**BRICKYARD ESTATES, ADMINISTRATIVE SUBDIVISION PLAN  
NO. 620230150 AND PRELIMINARY / FINAL FOREST  
CONSERVATION PLAN NO. F20230390**

No. 620230150 & F20230390

MCPB Item No. 13

Date: 2-29-2024

## FIRE ACCESS PLAN - ALTERNATIVE NEW LONDON DR EXTENSION

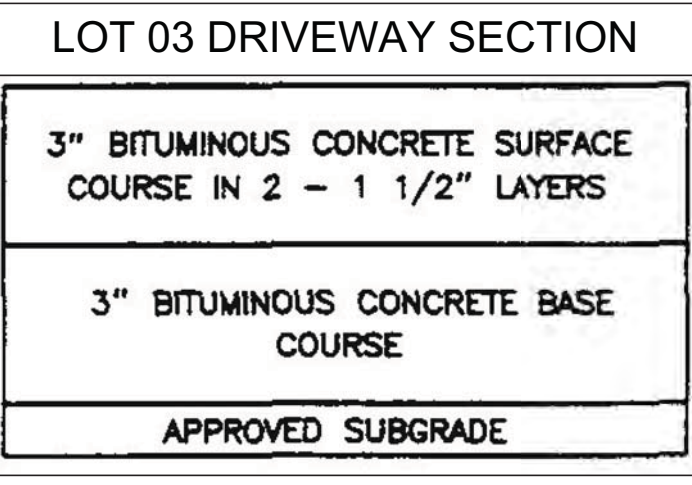
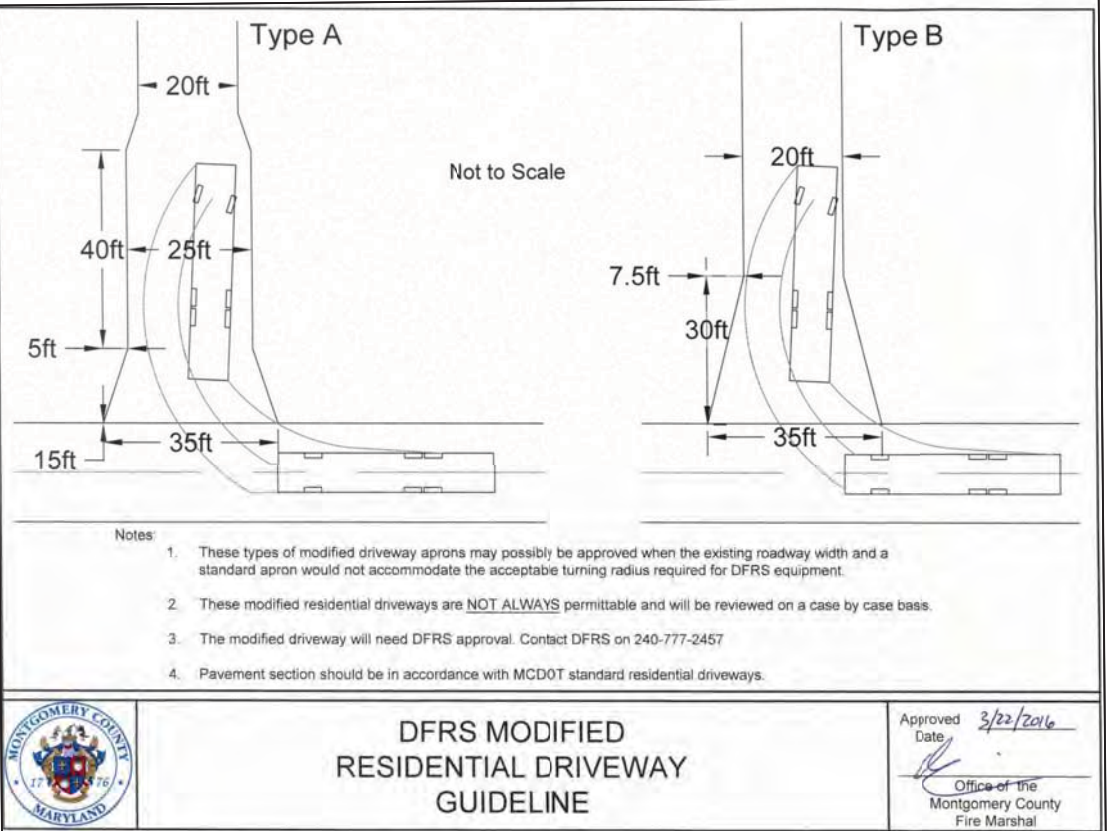
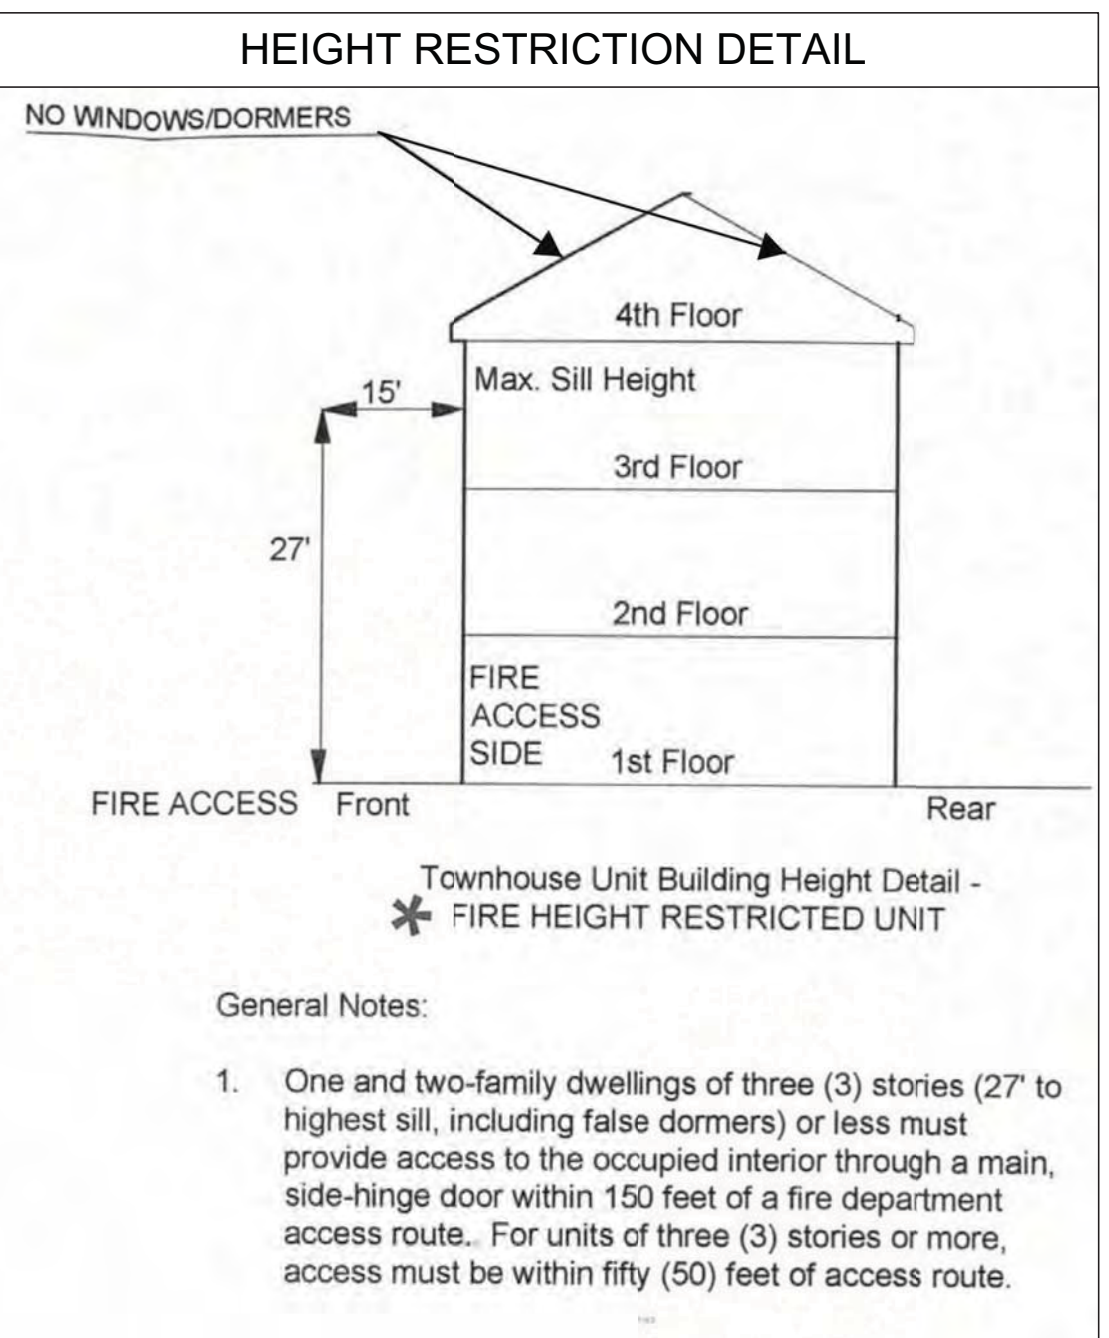
- FIRE ACCESS PLAN KEYNOTES**
- NEW FIRE HYDRANT LOCATED OUTSIDE OF PROPOSED CONCRETE ROADSIDE DITCH AND 3' OFFSET ROAD SURFACE OR ON THE OPPOSITE SIDE OF STREET IF LOCATION IS NOT POSSIBLE. CONNECT TO EXISTING 12" WATER MAIN WITH 12"x6" TEE AND PROVIDE 6" MJ VALVE (WSSC STD. W-8.1)

- ALL NEW STRUCTURES TO BE HEIGHT RESTRICTED TO 3-STORIES (27' TO HIGHEST SILL) AND PROVIDE ACCESS THROUGH A MAIN, SIDE-HINGE DOOR WITHIN 150' OF A FIRE DEPARTMENT ACCESS ROUTE. SEE HEIGHT RESTRICTION DETAIL ON THIS SHEET

- EXISTING NON-COMPLIANT CONDITION AT THE INTERSECTION OF BRICKYARD RD AND HACKAMORE DR
  - 20' WIDE LOT 03 RESIDENTIAL DRIVEWAY TO BE USED AS FIRE DEPARTMENT TURNAROUND PROVIDED LENGTH: 63' MINIMUM 60' ROADWAY PROVIDED ON EITHER SIDE OF DRIVEWAY ENTRANCE PROVIDE PAVING AND SUBGRADE PER TERTIARY RESIDENTIAL STREET (MC-201.01) SEE DRIVEWAY SECTION ON THIS SHEET
